Valmet Resubmit Certified
Reviewed With Comments
By Pierre Borduas on Oct 06, 2025
This review does not supersede requirements of purchase order, design drawings, specifications, codes or regulations. The contractor / supplier is not relieved from responsibility for errors or omission.

VALMET
DISSOLVING TANK
EQUIP. #
CUST. PO #S30019941

DRAWING NO.: 089-25-1 SHT 1 OF 13 REV. SET 0

PLAN VIEW

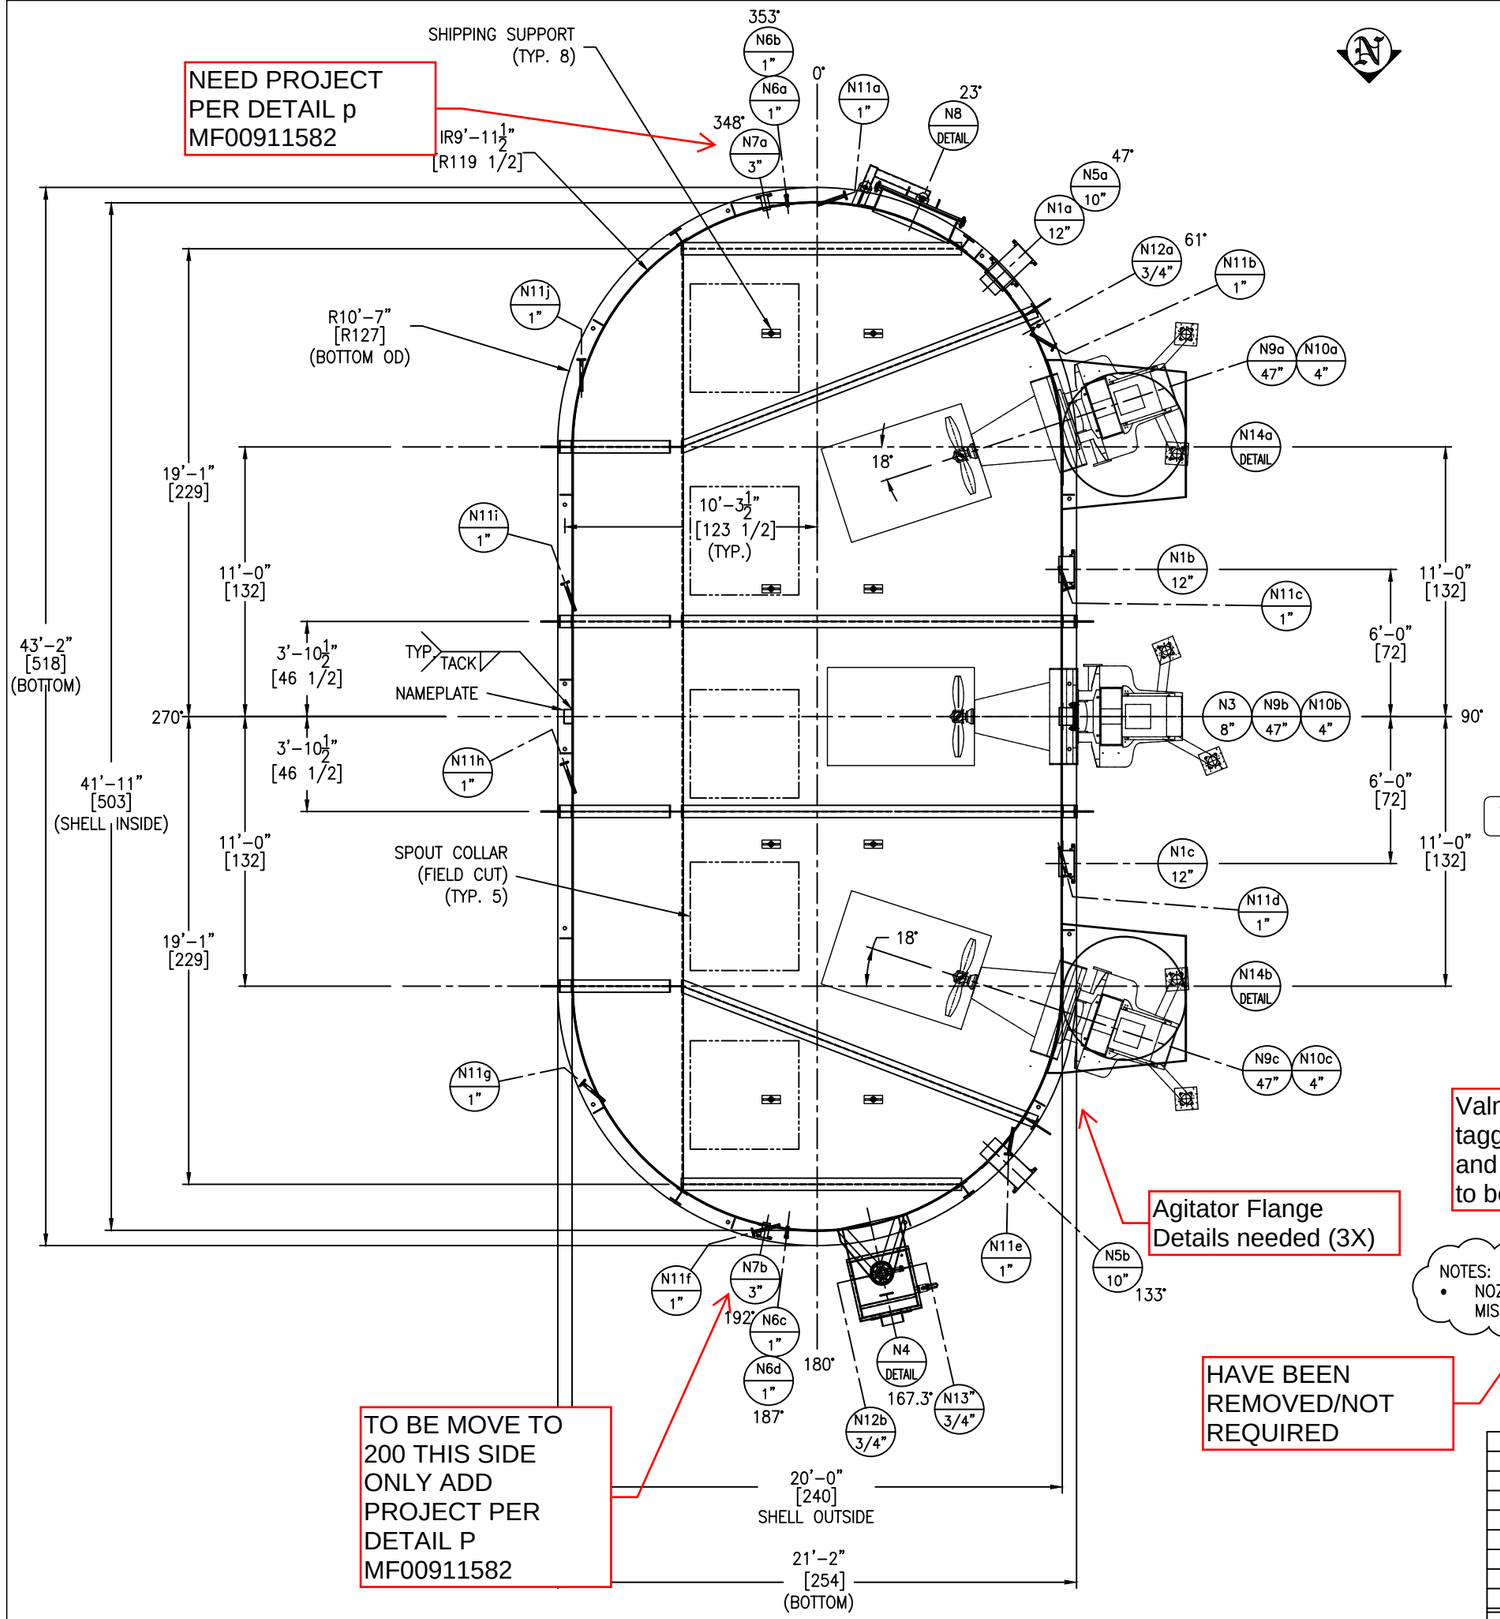
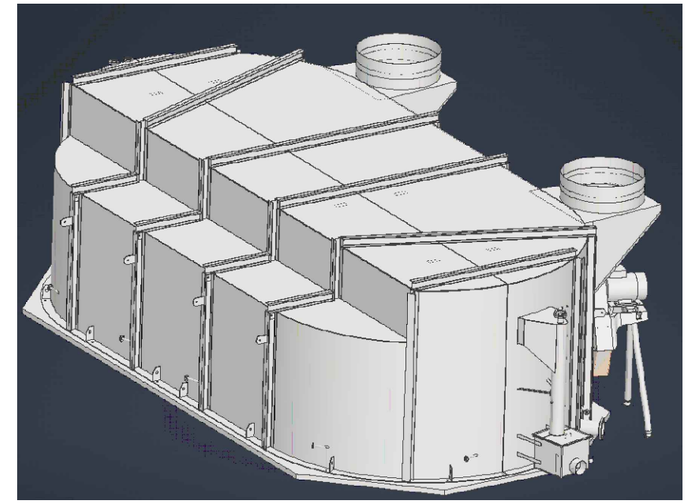
Valmet supply internal ring/ repad fab and install by supplier

HAVE BEEN REMOVED/NOT REQUIRED

SHOULD BE TWO PIECES

NEED TO ADD REPAD 2.5" WIDE

SHIPPING LAYOUT DETAIL

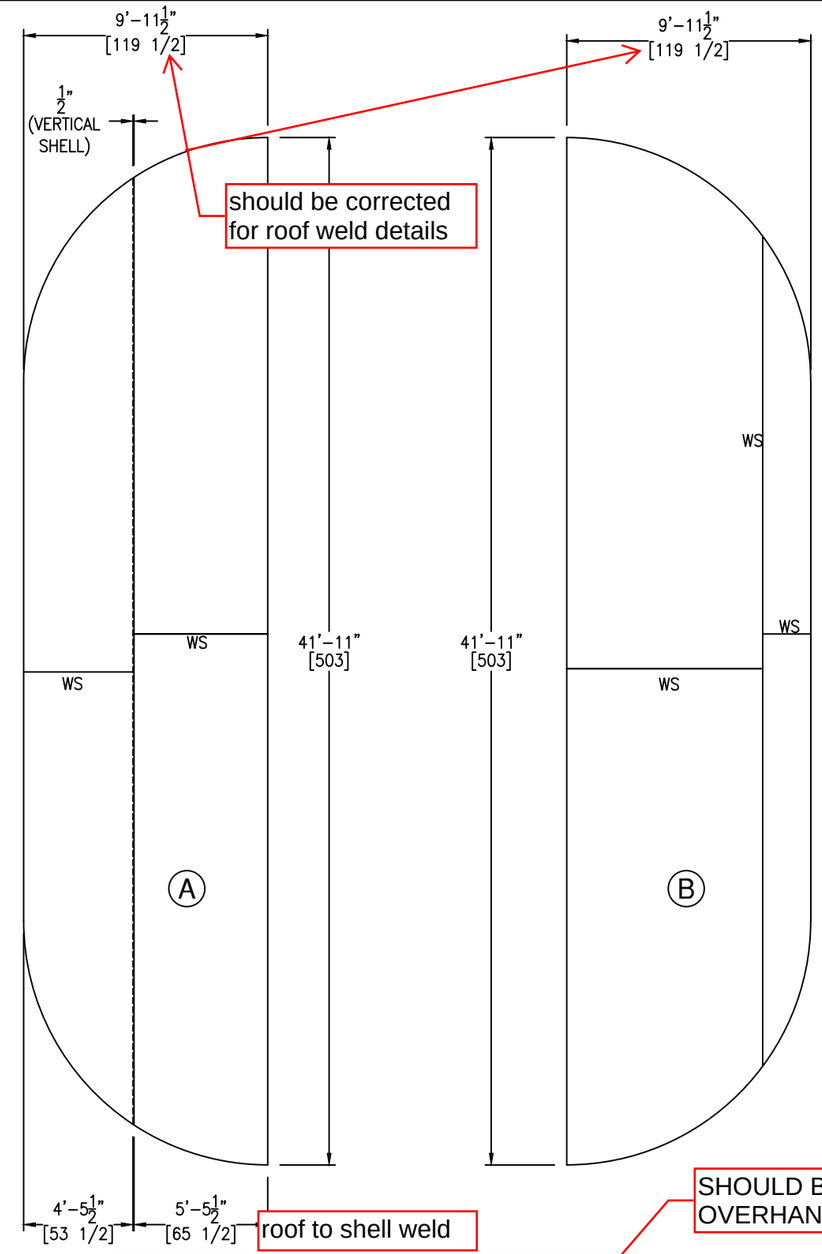
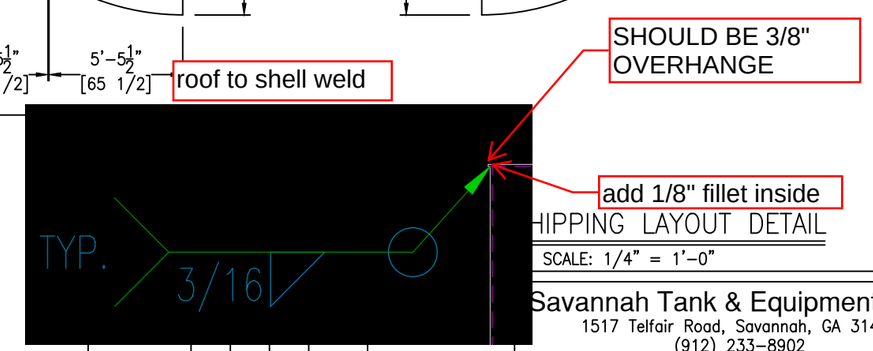
floor to shell weld

roof to shell weld

STACK CONNECTION DETAIL

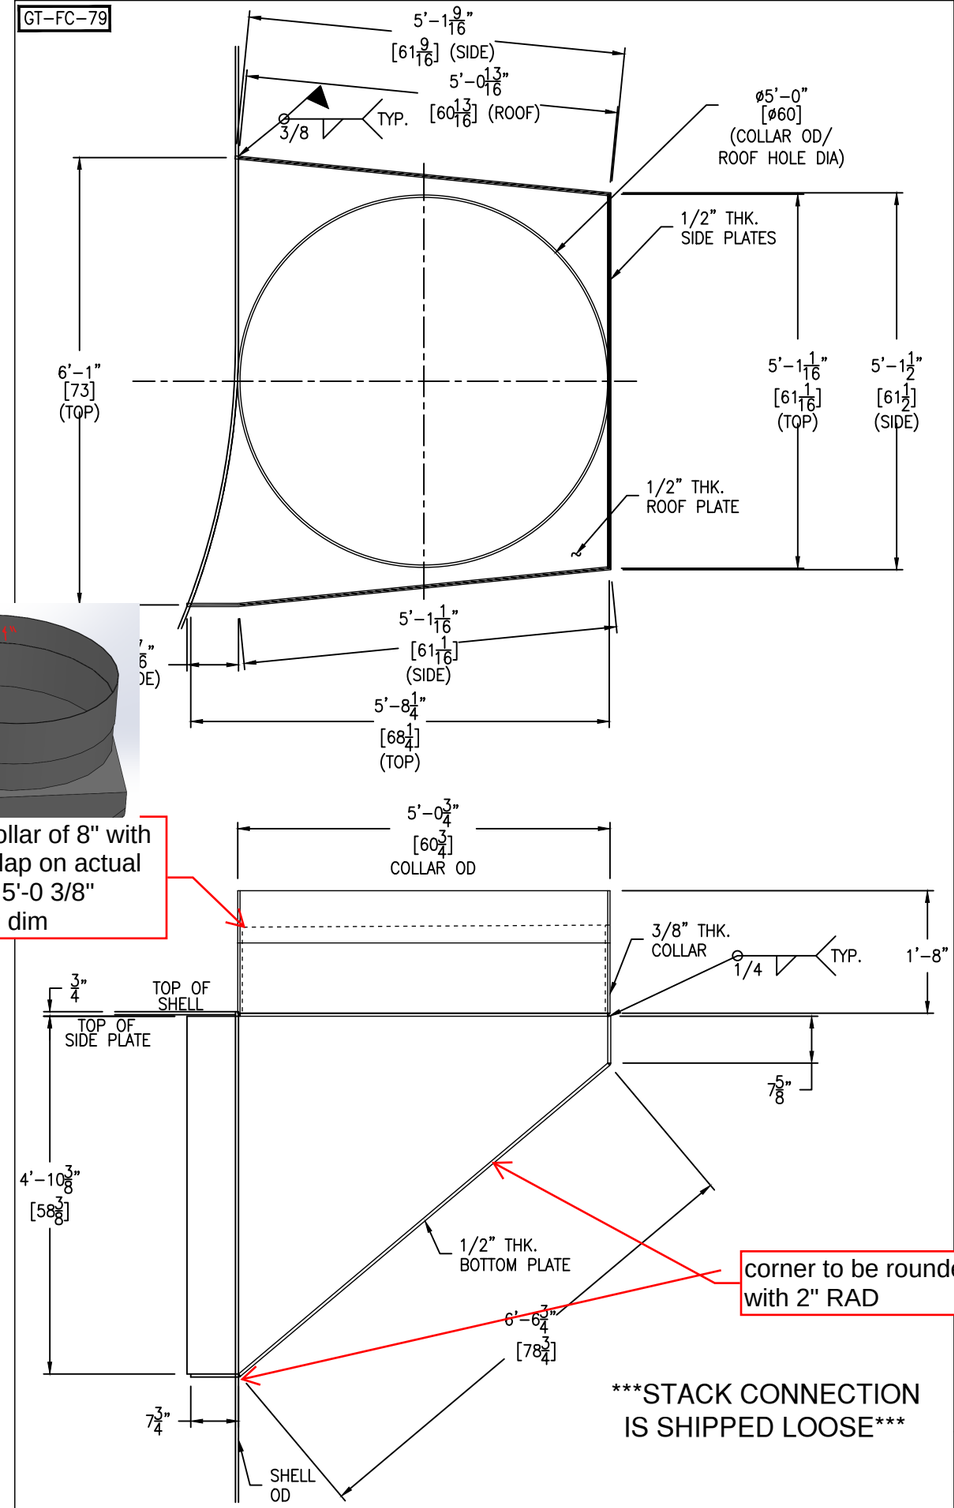
fit up collar of 8" with 4" overlap on actual duct of 5'-0 3/8" outside dim

corner to be rounded with 2" RAD

COLLAR OPENING AND AGITATOR WEAR PLATE LOCATION DETAIL

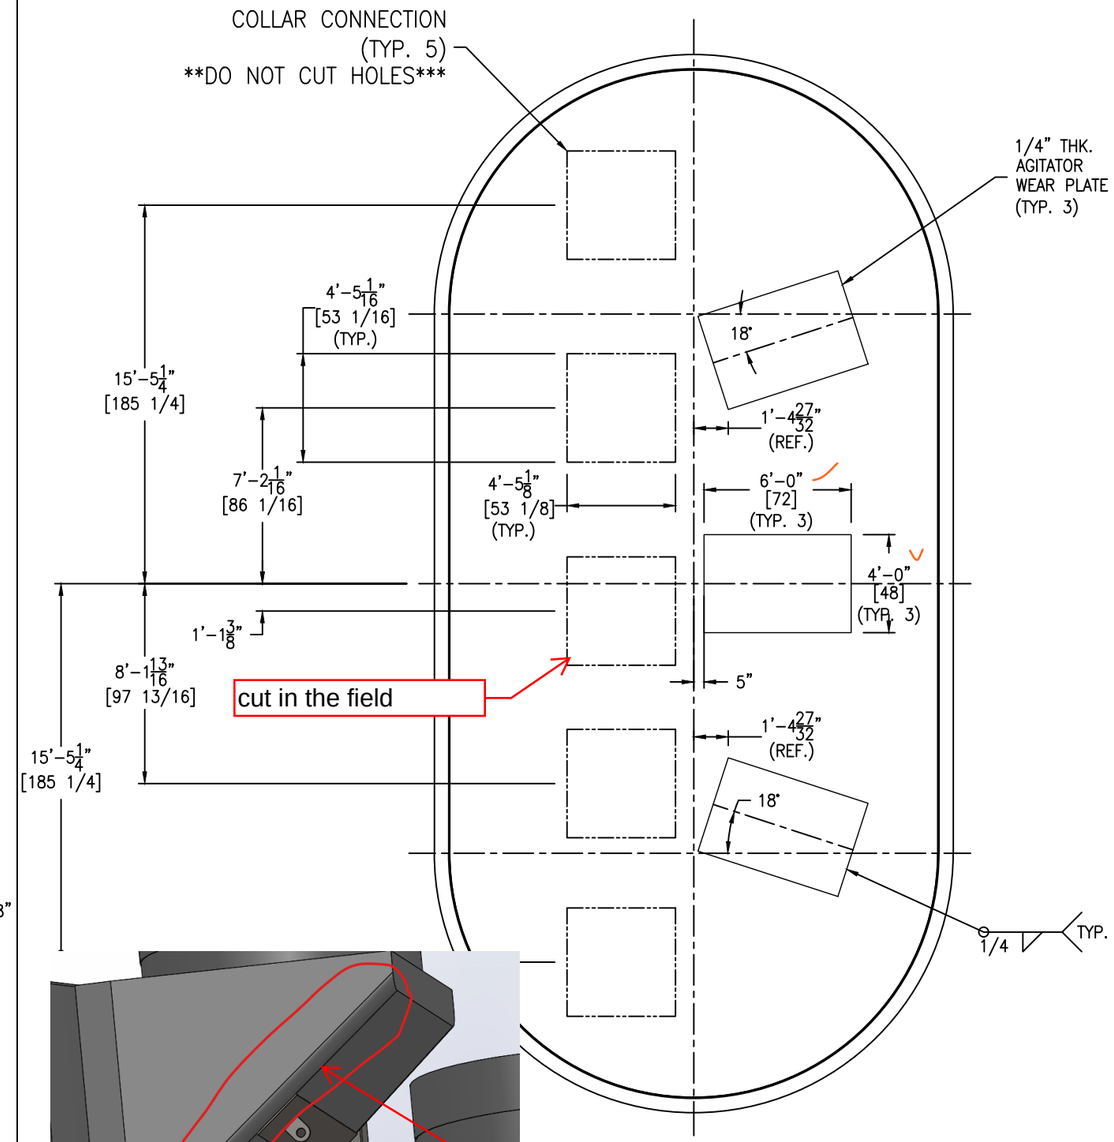
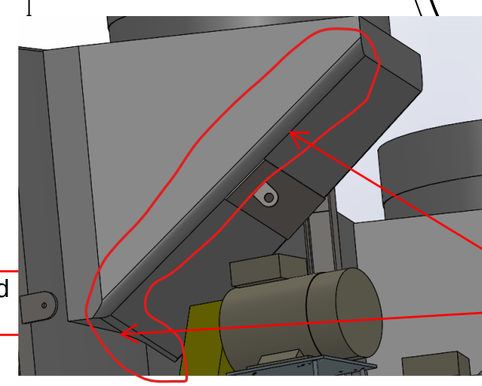
rounded corner

(SS304/L) OVERFLOW ASSEMBLY DETAIL

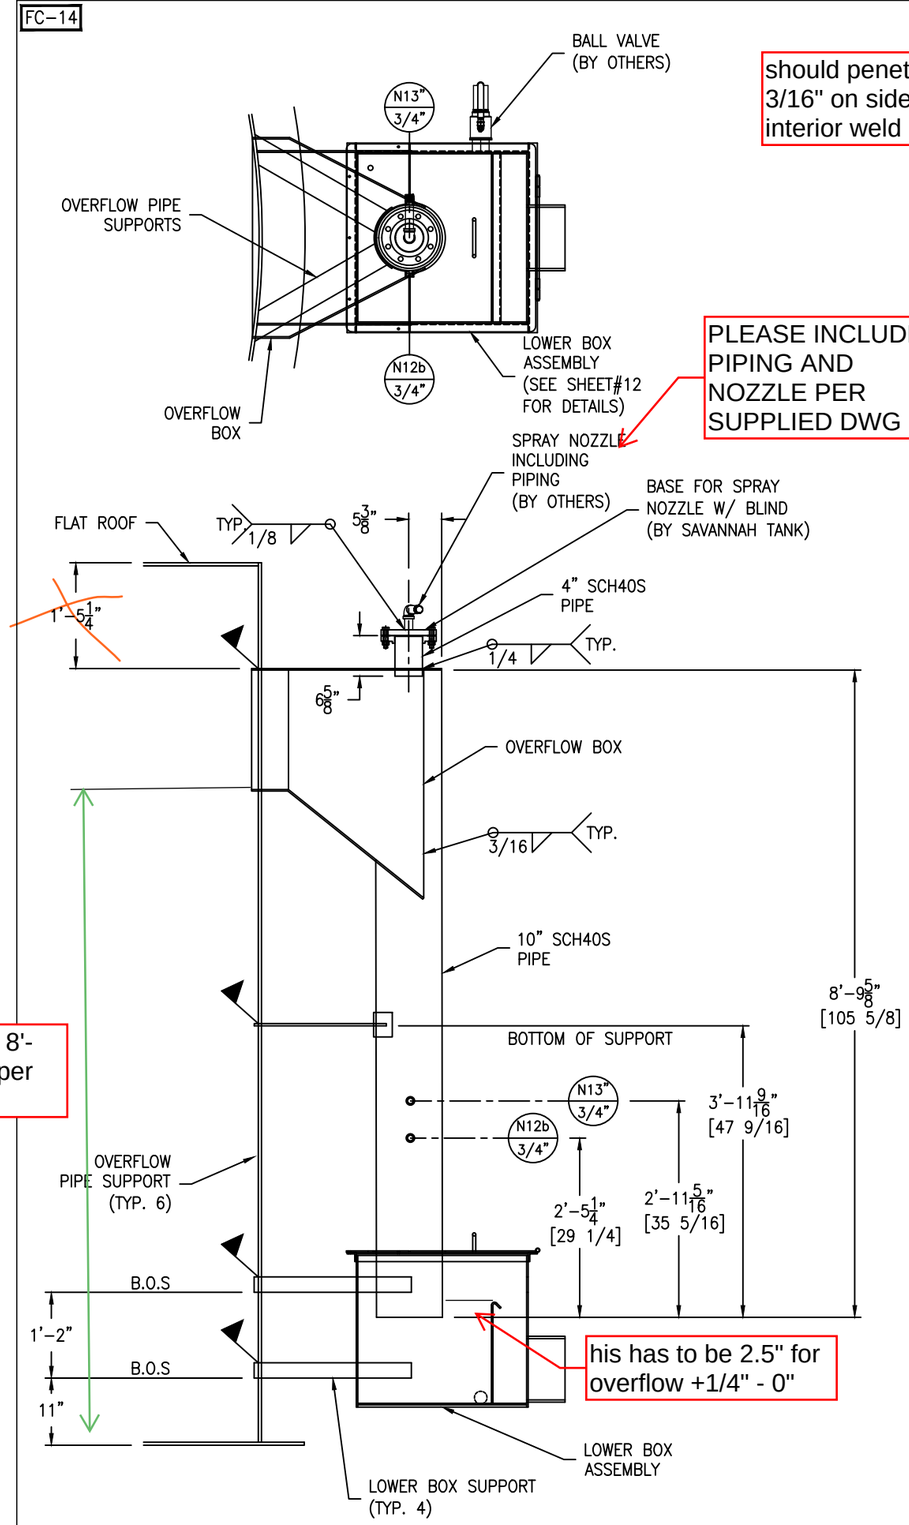
PLEASE INCLUDE PIPING AND NOZZLE PER SUPPLIED DWG

need to be 8'-11" for proper overflow

his has to be 2.5" for overflow +1/4" - 0"

should penetrate 3/16" on sides for interior weld

OVERFLOW BOX DETAIL

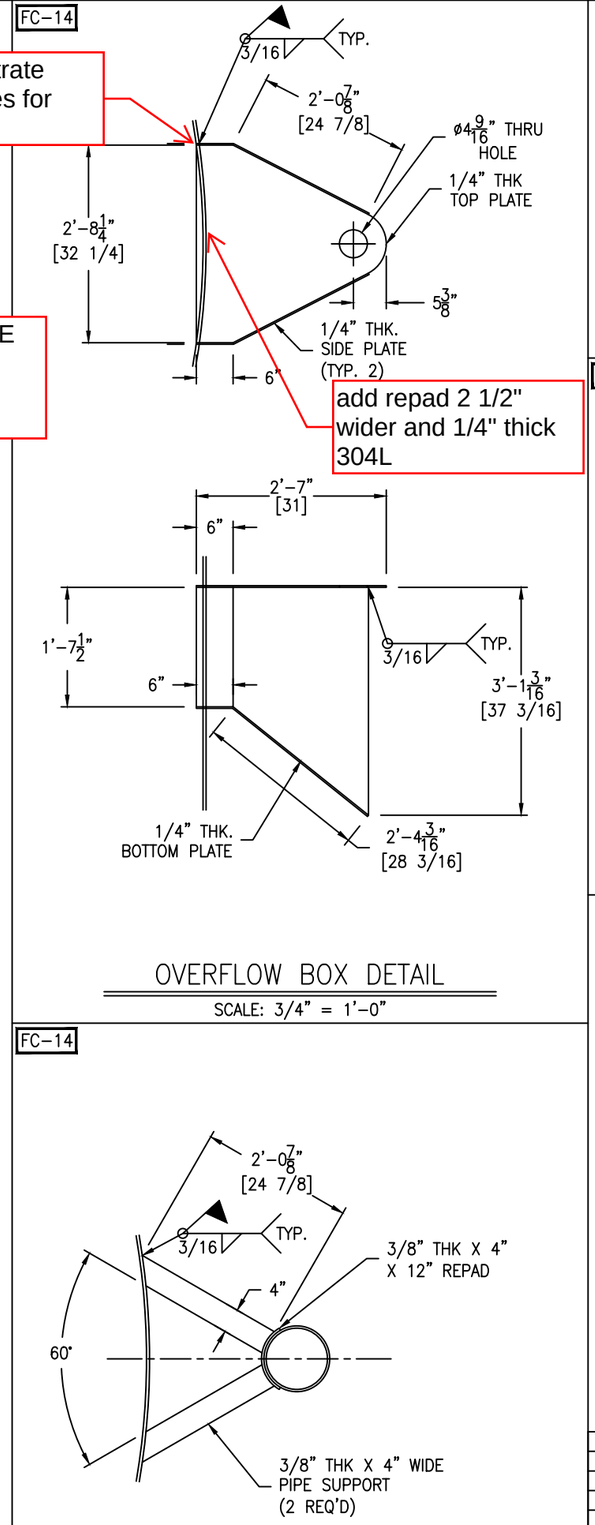
add repad 2 1/2" wider and 1/4" thick 304L

N5a & N5b DETAIL

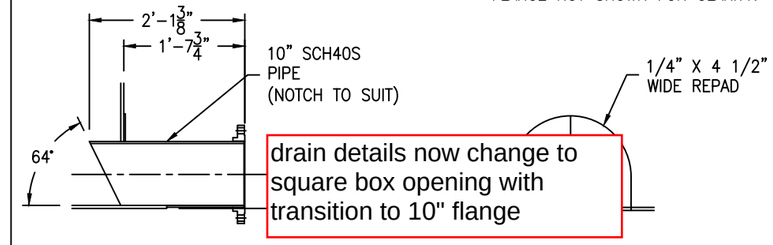
drain details now change to square box opening with transition to 10" flange
